Permit Number: 031067

Date: November 10, 2003
Architect's Project No.: 03034

**ADDENDUM NO. 4
TO
CONTRACT DRAWINGS AND SPECIFICATIONS
FOR
GULF OF MAINE RESEARCH LABORATORY
Portland, Maine**

PROJECT: THE GULF OF MAINE RESEARCH INSTITUTE
 SUBJECT: REGRADING REVISIONS TO CG101

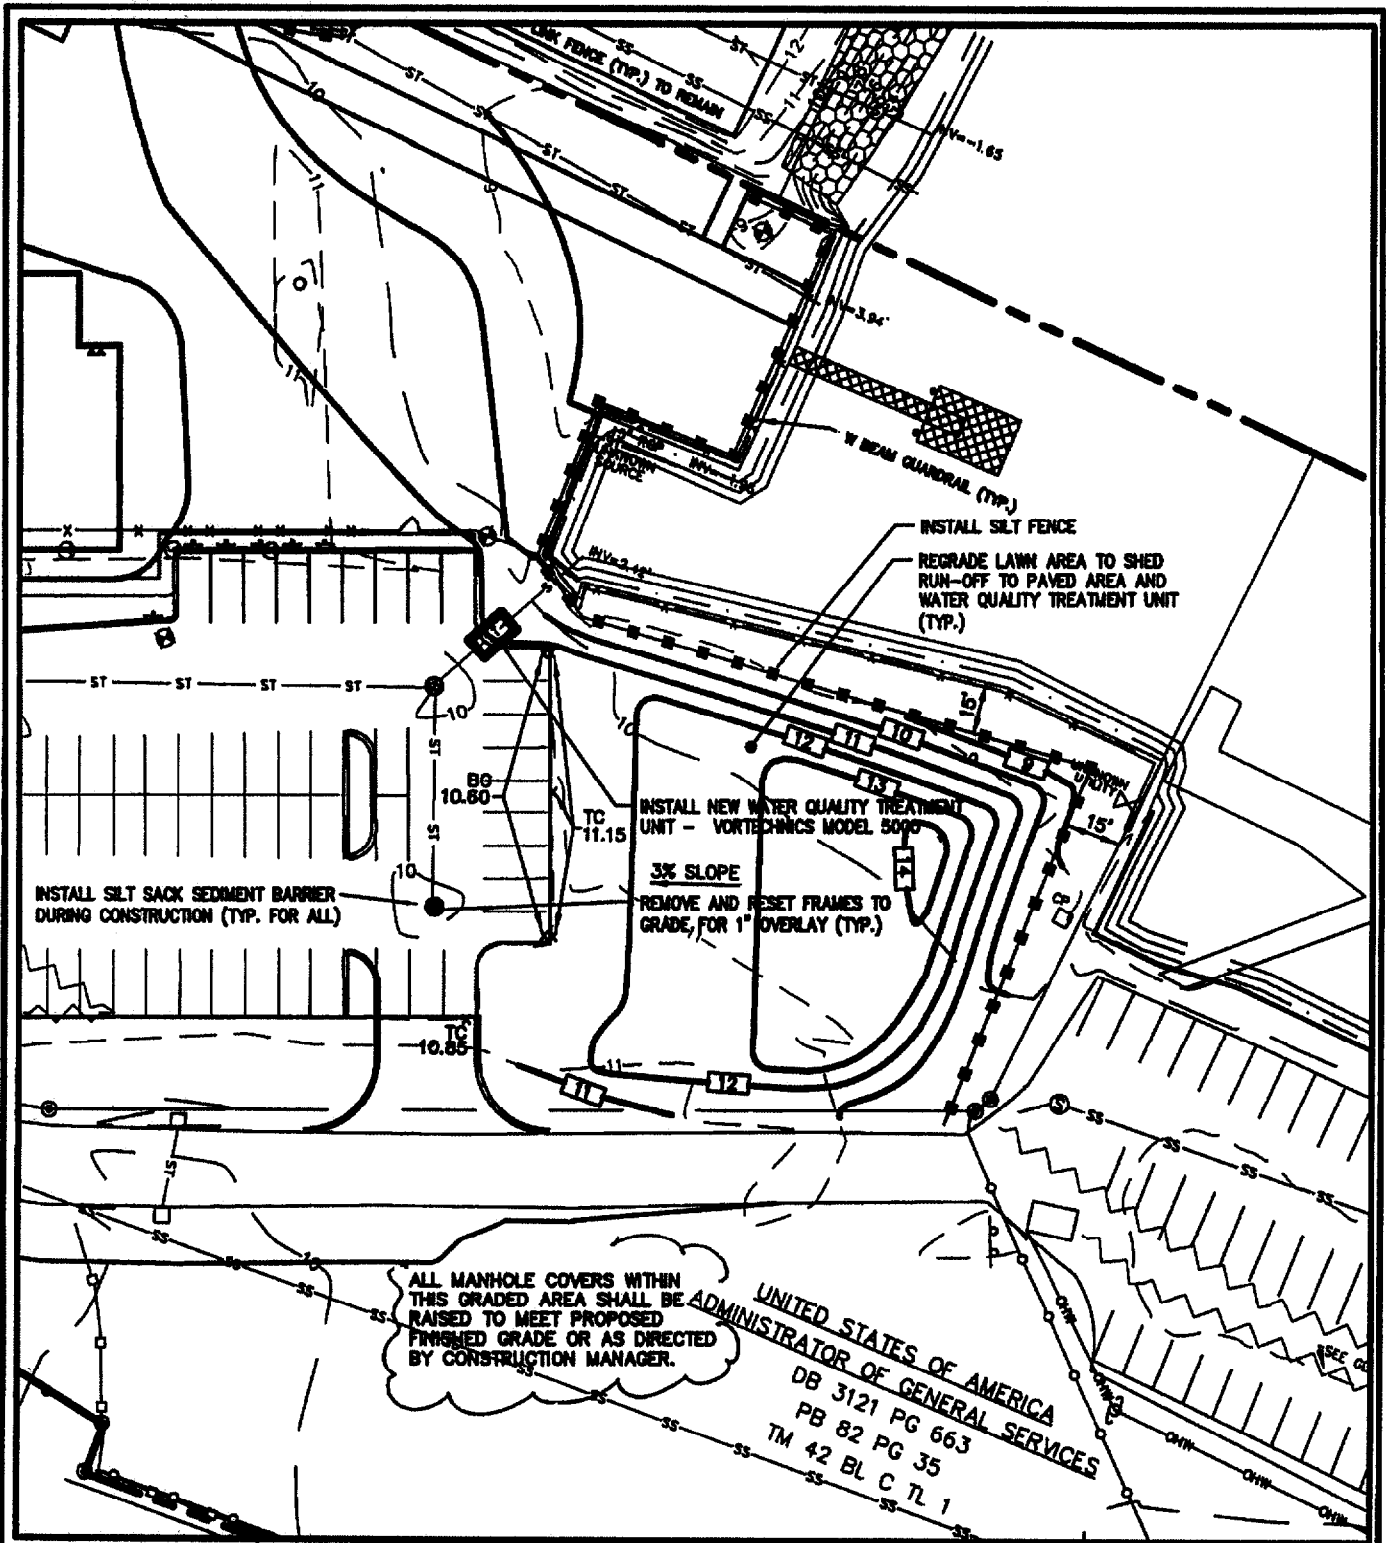
ALL MANHOLE COVERS WITHIN THIS GRADED AREA SHALL BE RAISED TO MEET PROPOSED FINISHED GRADE OR AS DIRECTED BY CONSTRUCTION MANAGER.

REVISED DETAIL H/SW108

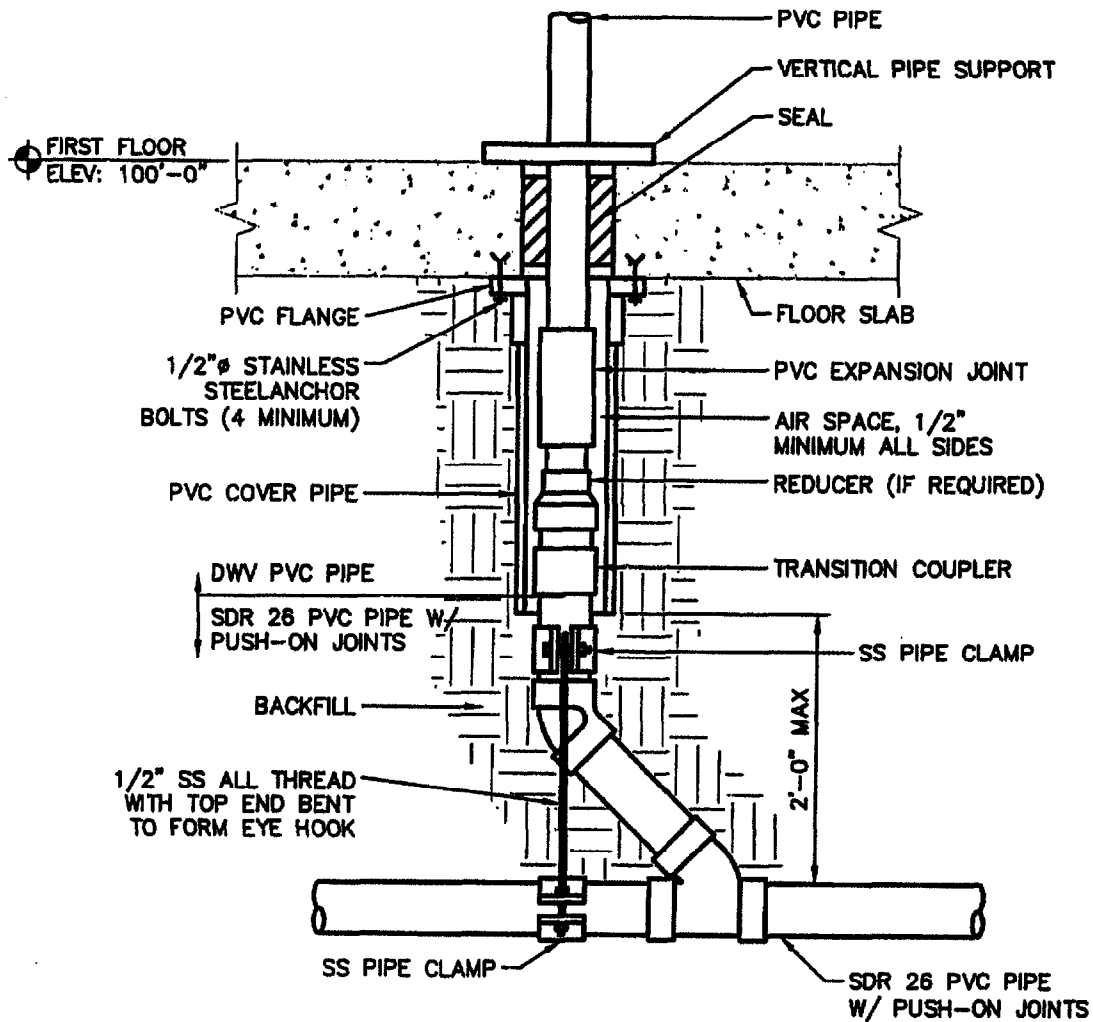
22. Drawing Sheet SW104:
 - A. Change elevation of FSW and TSW piping from "APPROX. INV. EL. 108'-0"" to read: "APPROX. INV. EL. 108'-6"".
 23. Drawing Sheet SW108. Delete detail "H – Seawater Riser Detail" and replace with detail "H – Seawater Riser Detail" as shown on attached sketch ADD4-SW1.

H SEAWATER RISER DETAIL
 SW114 SCALE: NTS

E-2

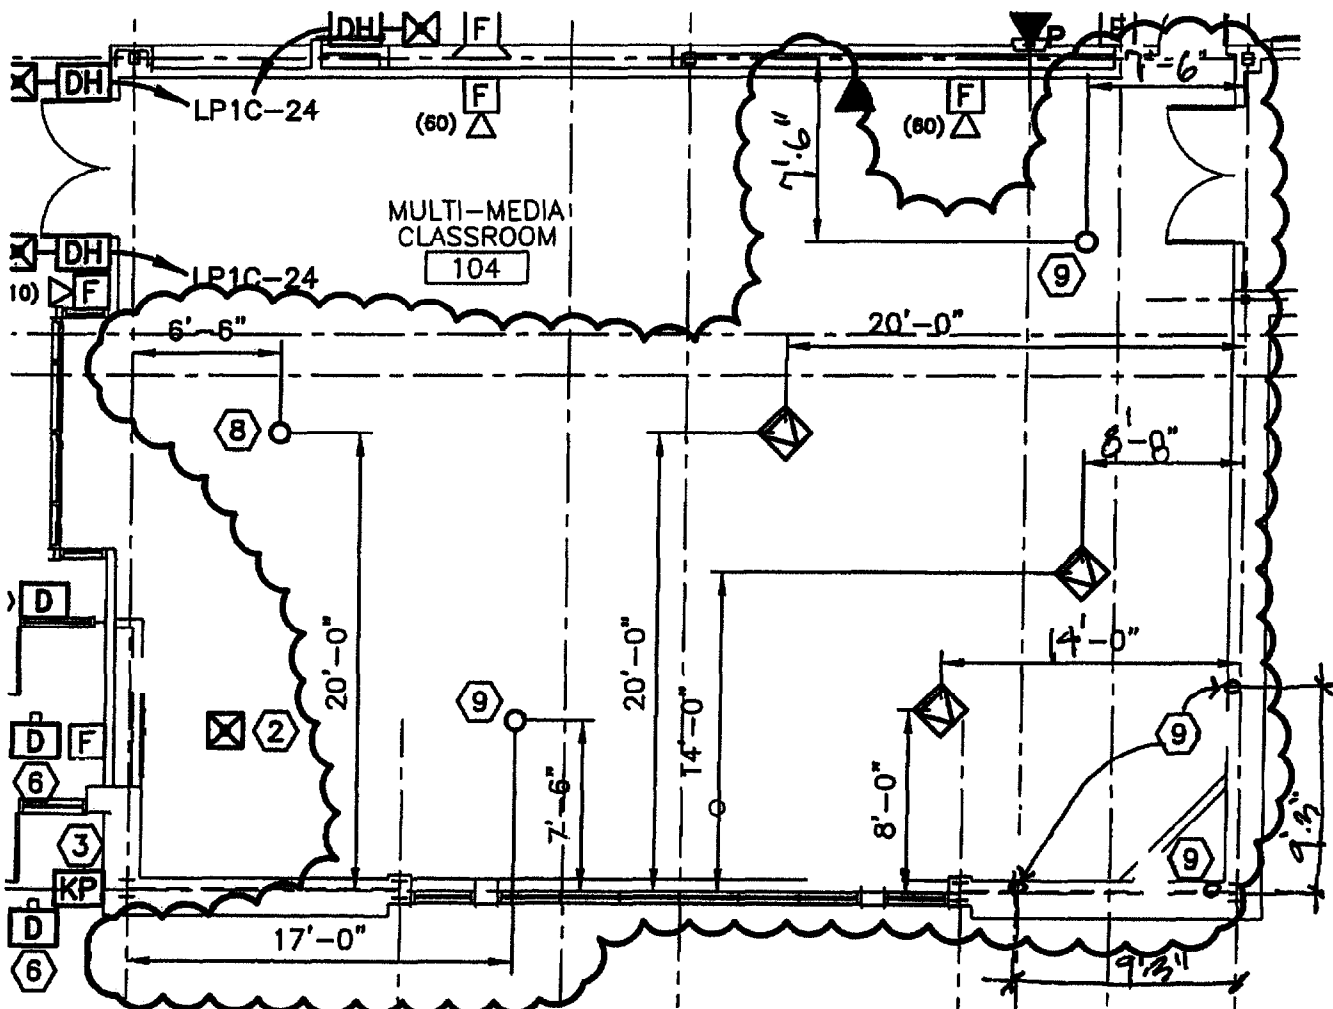
27. Drawing Sheet EY101. Revise data outlets as shown in attached sketch E2.

⑧ PROVIDE (2)-2" CONDUITS BETWEEN SCHOOLING TANK AND EQUIPMENT RM. 202

⑨ PROVIDE (1)-1" CONDUIT BETWEEN LAB VENTURE STATION AND EQUIPMENT RM. 202
